Technology Readiness Assessment Summary

Waste Treatment and Immobilization Plant (WTP) Pretreatment Facility

TRA Summary: August 2011

Block Diagram of Cesium Nitric Acid Recovery

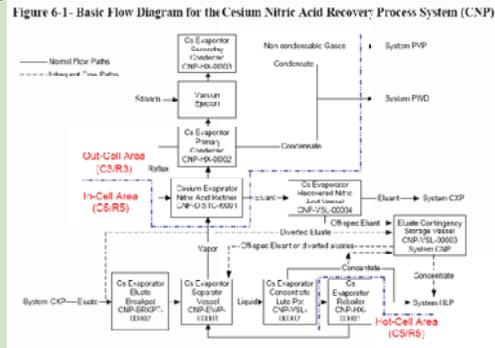
- Discontinue design of the Cesium Nitric Acid Recovery Process (CNP) until: (1) a reassessment of the design and operational requirements is completed, (2) the engineering specification is revised to reflect operational conditions, and (3) the technology concept is demonstrated through integrated prototypic testing.

- Testing the CNP prior to installation in the black cell using representative feed compositions to verify the process control concept and the ability to control and monitor the composition of the nitric acid product, and to demonstrate the Cs decontamination factor of 5 million and the ability to decontaminate the demister pads.
